**TOWN OF NEWBURGH
PLANNING BOARD
TECHNICAL REVIEW COMMENTS**

PROJECT NAME: VANTAGE CONSTRUCTION
PROJECT NO.: 23-03
PROJECT LOCATION: SECTION 11, BLOCK 1, LOT 66.21/KINGS HILL ROAD
REVIEW DATE: 31 AUGUST 2023
MEETING DATE: 7 SEPTEMBER 2023
PROJECT REPRESENTATIVE: NOSEK ENGINEERING/ACES SURVEYING

Re: Vantage Construction 4-Lot Subdivision
Kings Hill Road
Town of Newburgh, Orange County, N.Y.

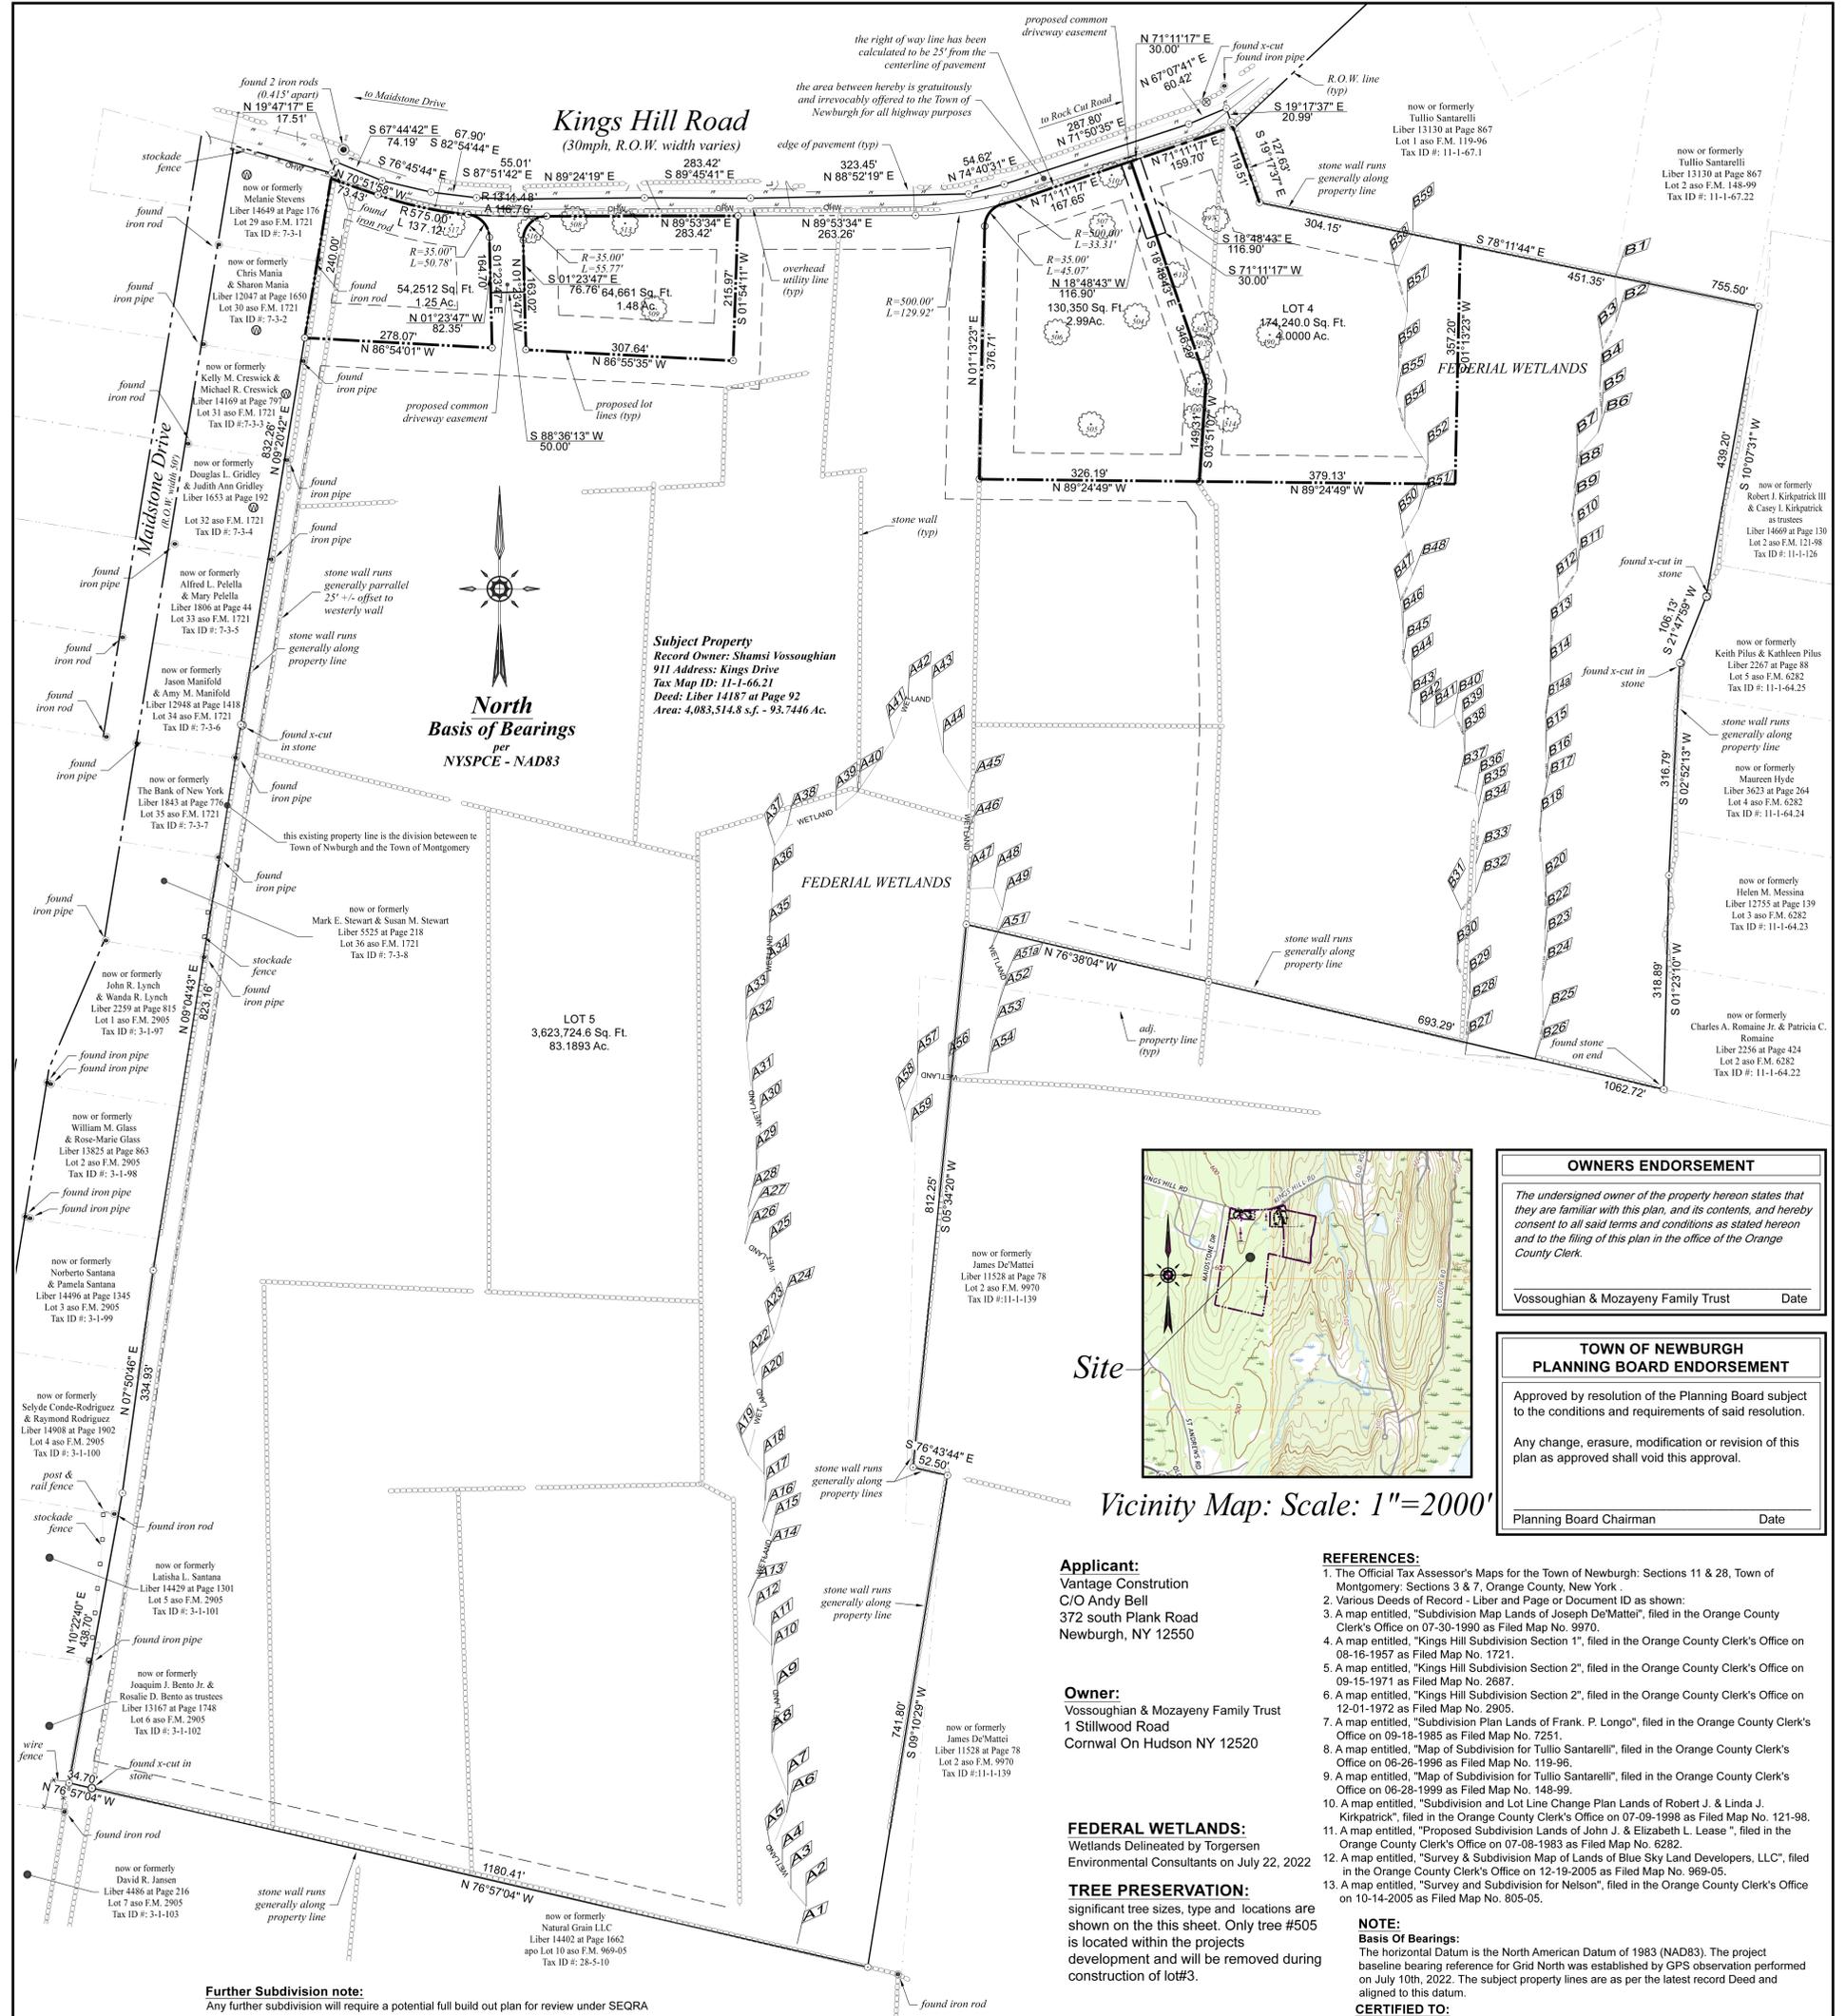
3. One significant tree is proposed to be removed for the subdivision. The majority of the site, 83.28 +/- acres will remain in its current state.
4. On the subdivision sheet the lots should be numbered. Only Lots #4 & 5 are numbered on Sheet 106.

PROPOSED DRIVEWAY SIGHT DISTANCES:
Lot #1 & lot #2 : left 500' - right 500'

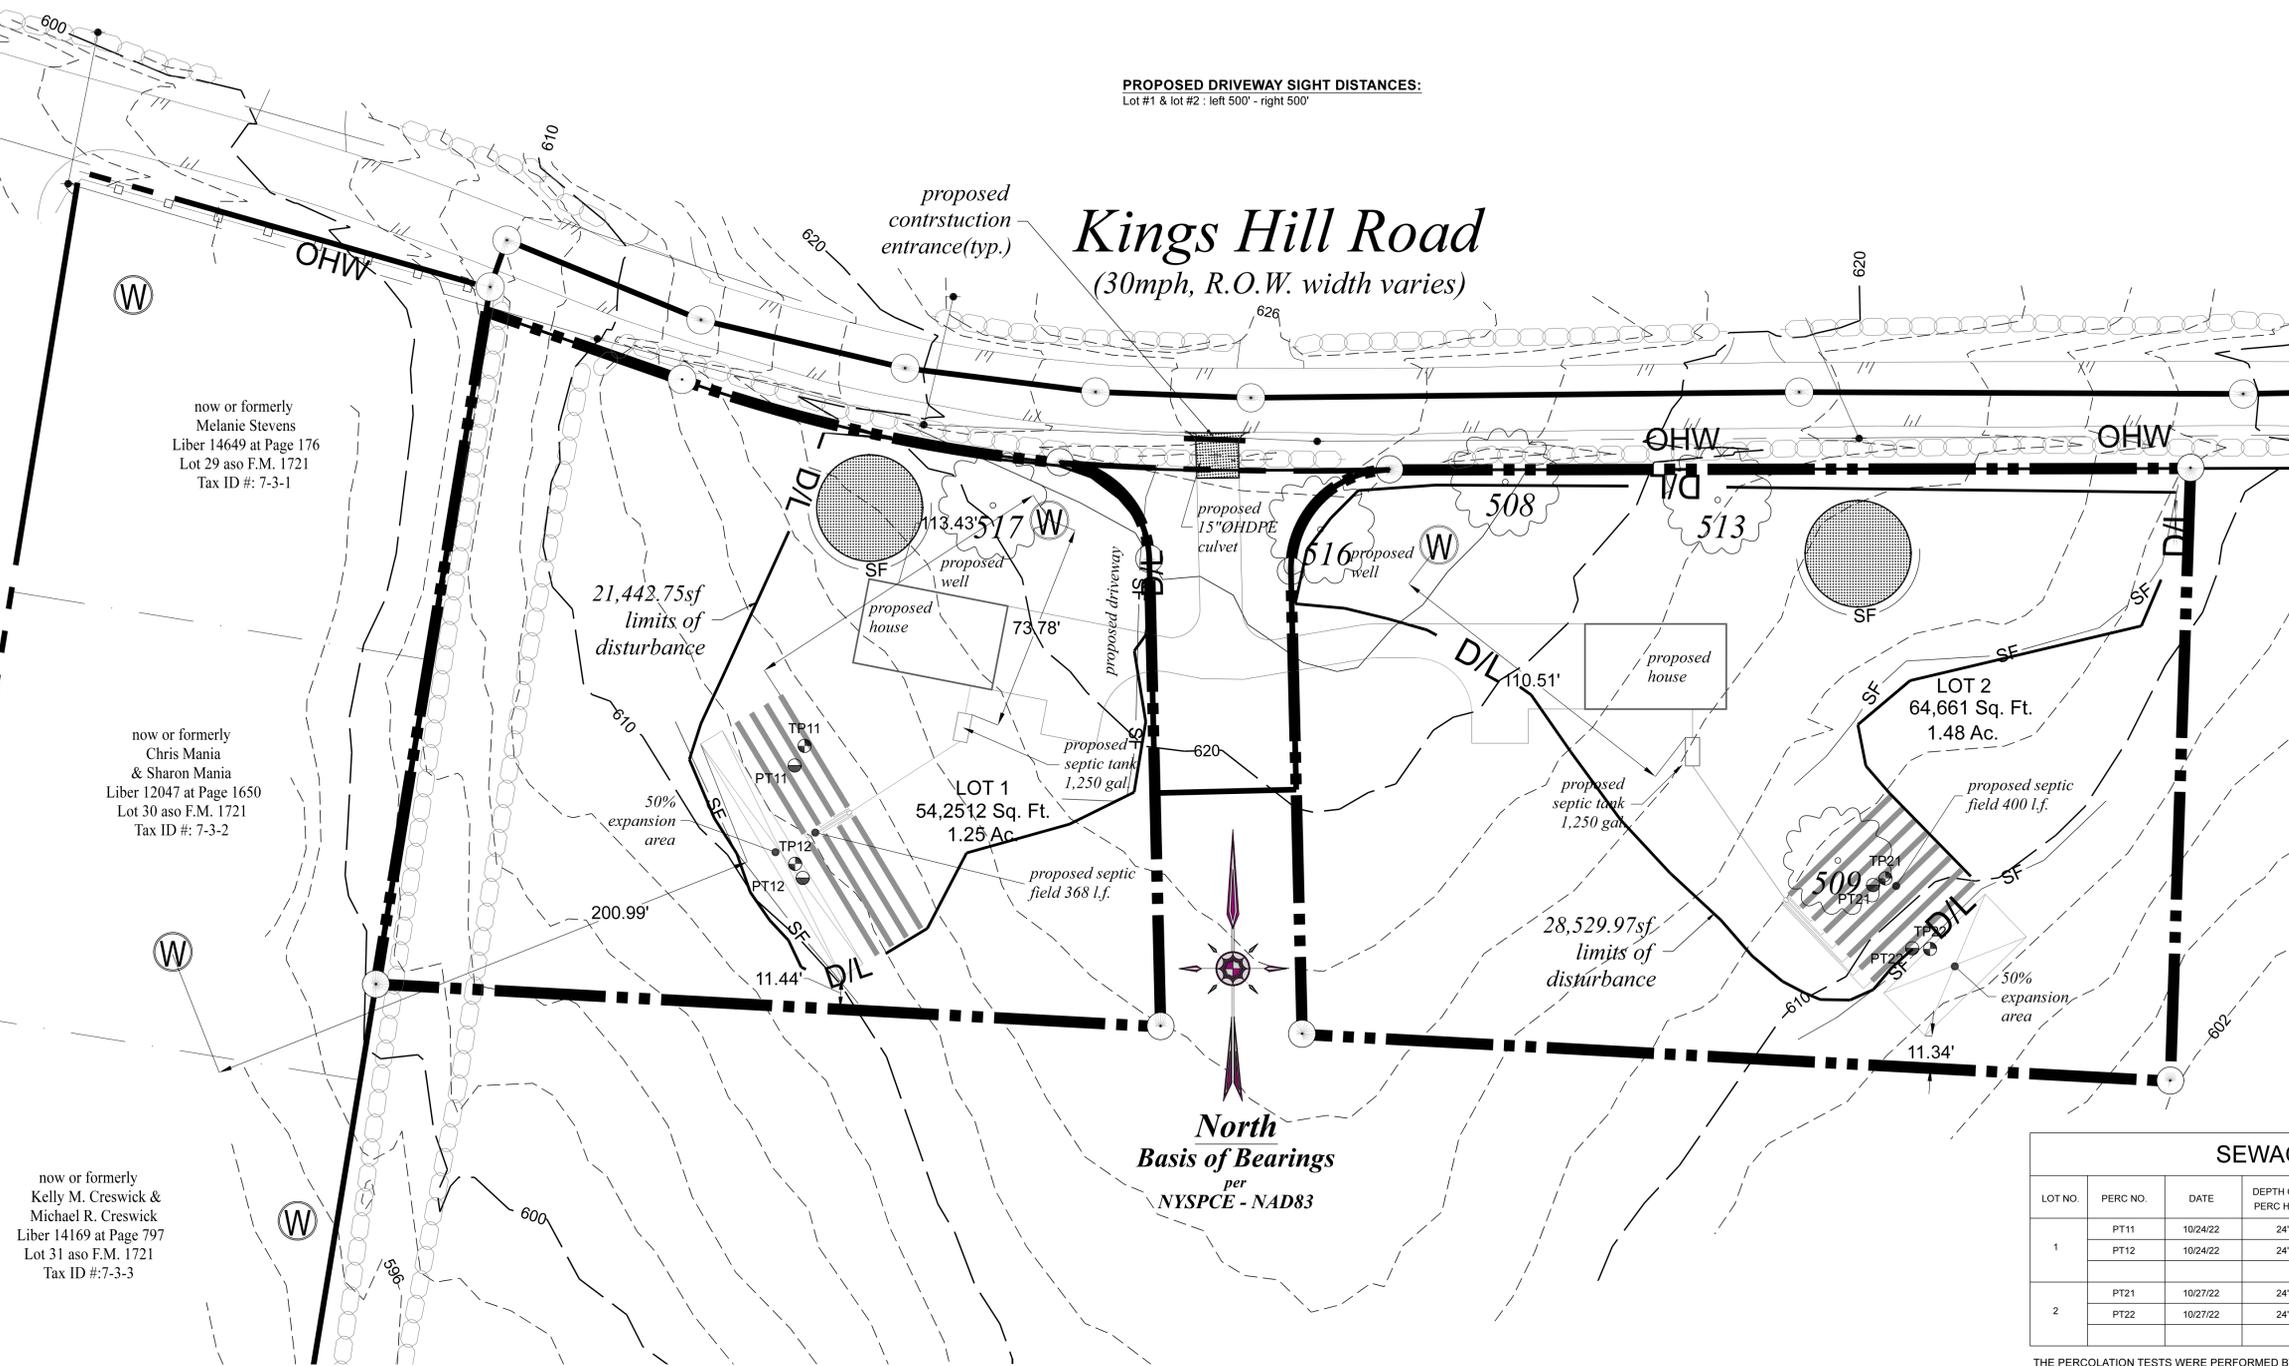
1. The driveways have been combined with two lots off each driveway. The driveway serving proposed Lot #1 & #2 is located within the 50 foot strip providing access to the balance parcel. These driveways will then be off of any future potential roadway should one be developed.

2. Common Driveway Access Maintenance Agreements and appropriate easements must be filed. Easements should have a clause requiring the driveways to access off any future roadway into the parent parcel.

1. The plans have been revised to relocate the driveways for lots 1 and 2 and combine to the 50 wide strip. We have included an easement with metes and bounds for both lots.
